Fashion Plus Ltd.

9 December 2025

1. Building Information

2. Observation

Observation-02: Slenderness exists in the shear walls and columns. (Main Building)

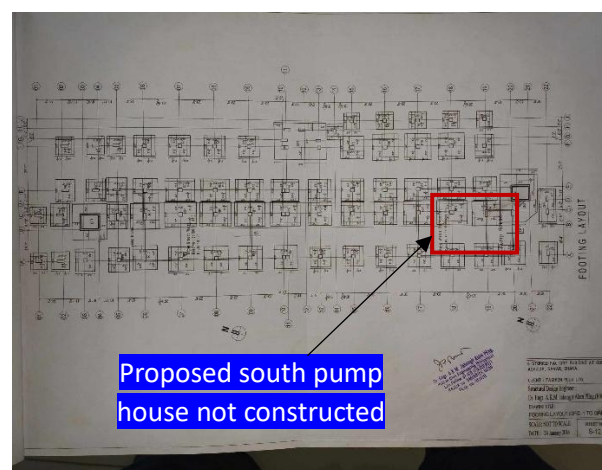
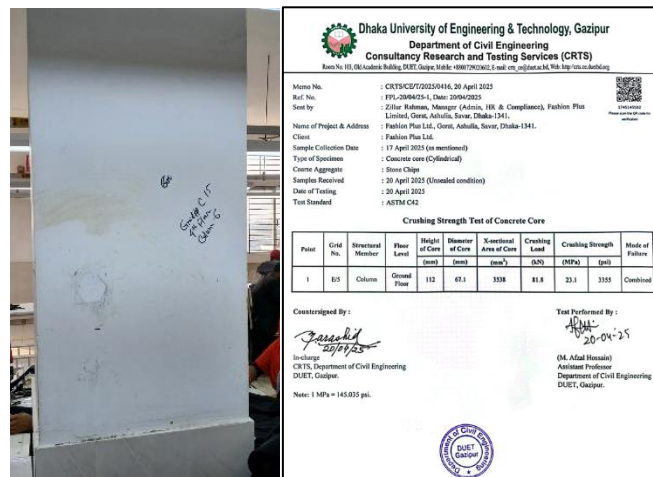
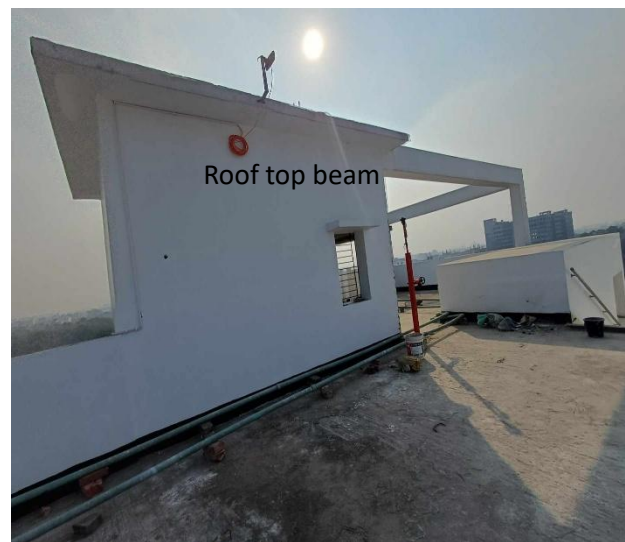
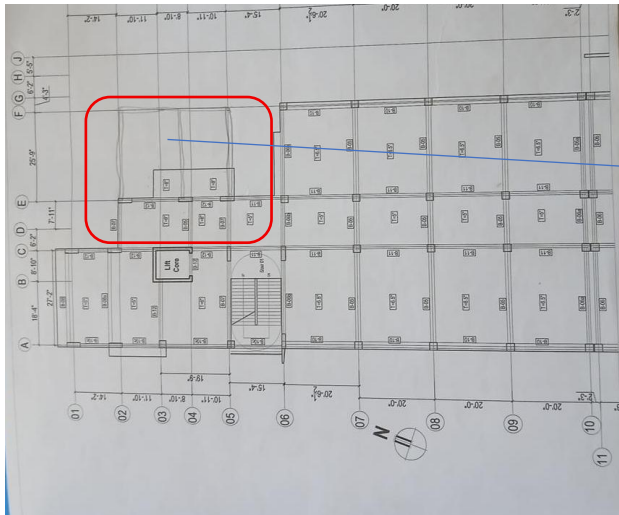
Description: The RC column (600mm X 600mm) unsupported length is 6m. Also, the shear wall (450mm X 1200mm) unsupported length is 9.2m. The height-to-thickness ratio of the shear wall and RC column exceeds the limit.

The building engineer is required to consider the slenderness effects in the design report.
